IFB: Exterior Wall Framing Repairs for Commons Dorm Apartments K4-2, K4-5

Project SU-060821

Addendum #1 \* August 19, 2021

Re: Addendum #1 – Additional Information & Clarifications

TEMPORARY BUILDING  
SHORING AND DEMOLITION  
PLANS

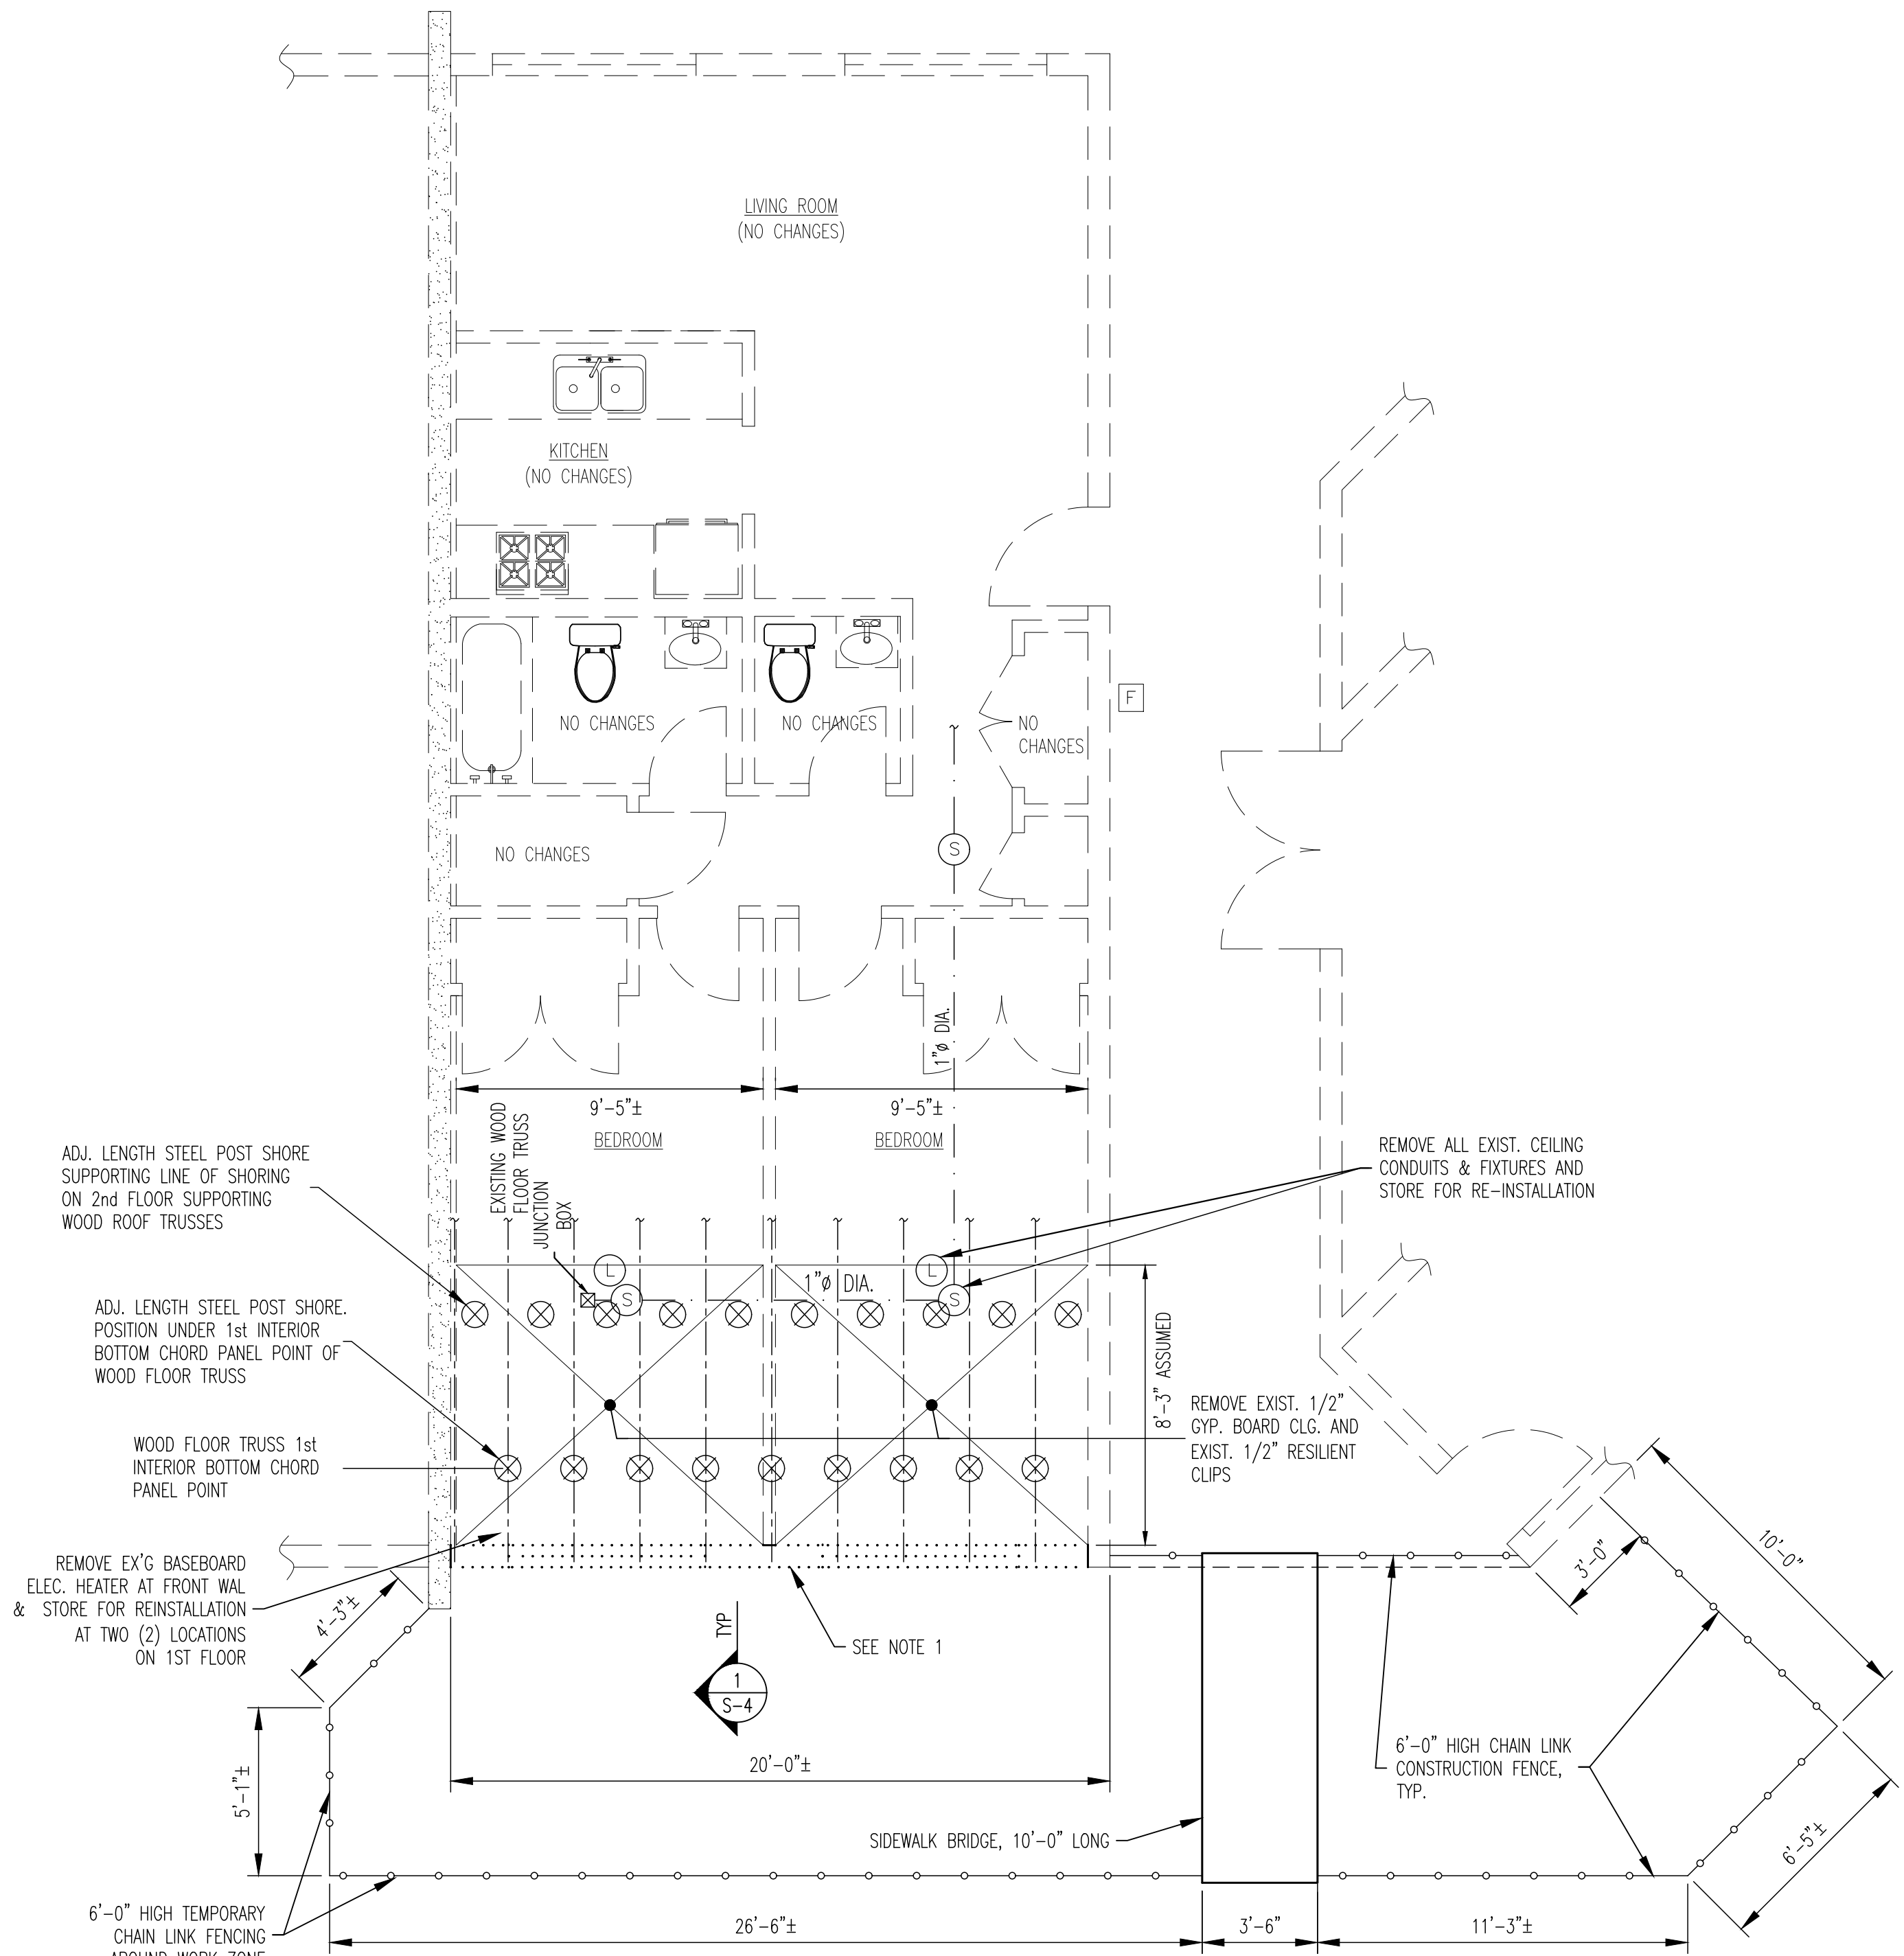
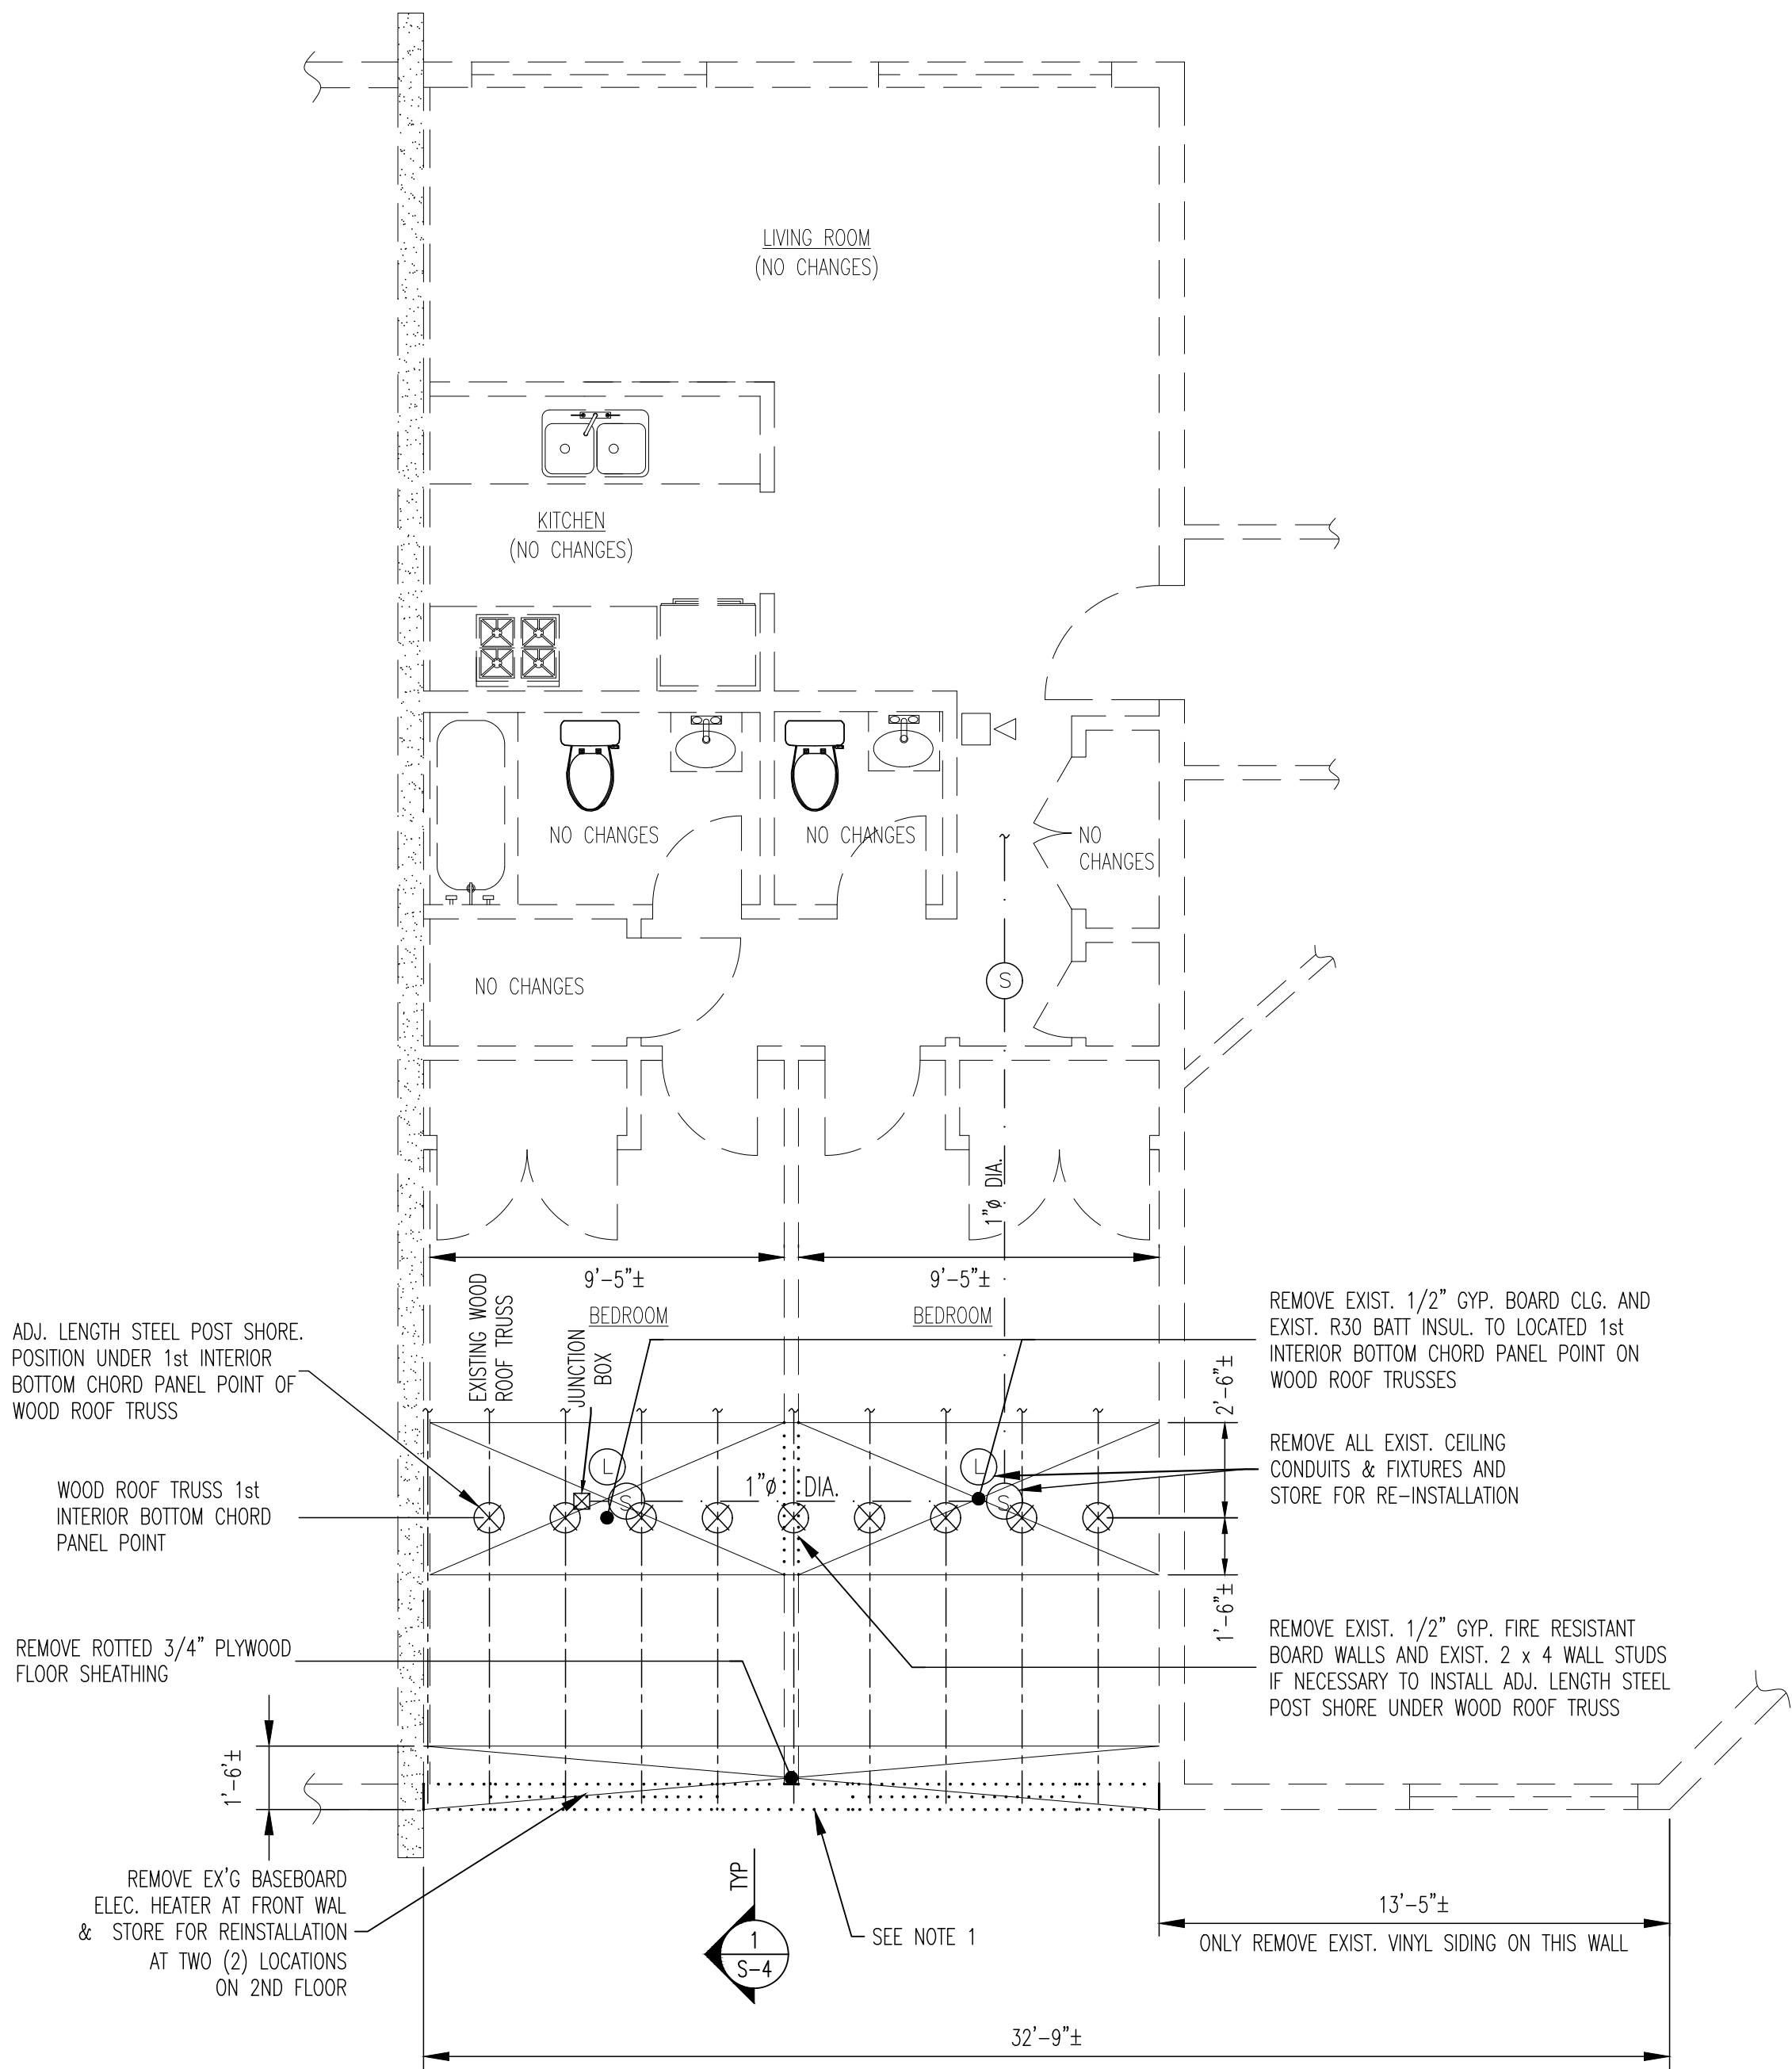
10. **Question:** The following materials are called out to match existing: VCT floor, Carpet, Siding. Please provide a manufacturer and color to match or confirm if Facilities will be providing materials from existing attic stock for use on this project.

12. **Question:** Upon inspection of the site, each room had a radiator and cover on the exterior wall. There appeared to be damage to at least the cover if not the radiator and piping. This will probably have to be replaced during the construction process. Can you provide a unit model or specification for replacement materials?

**Answer:** Follow the Contract Drawing, Revision 1, dated 8.19.21, which shows the removal and replacement in kind of the existing carpet in all four (4) bedrooms on the 1<sup>st</sup> and 2<sup>nd</sup> floors.

**Answer:** Follow the Contract Drawing, Revision 1, dated 8.19.21, which shows the removal and reinstallation of the existing electric baseboard heaters at four locations along the front wall. This incidental work is included in the lump-sum cost of the project. The damaged cover is an aesthetic issue, doesn't affect the radiator's operations.
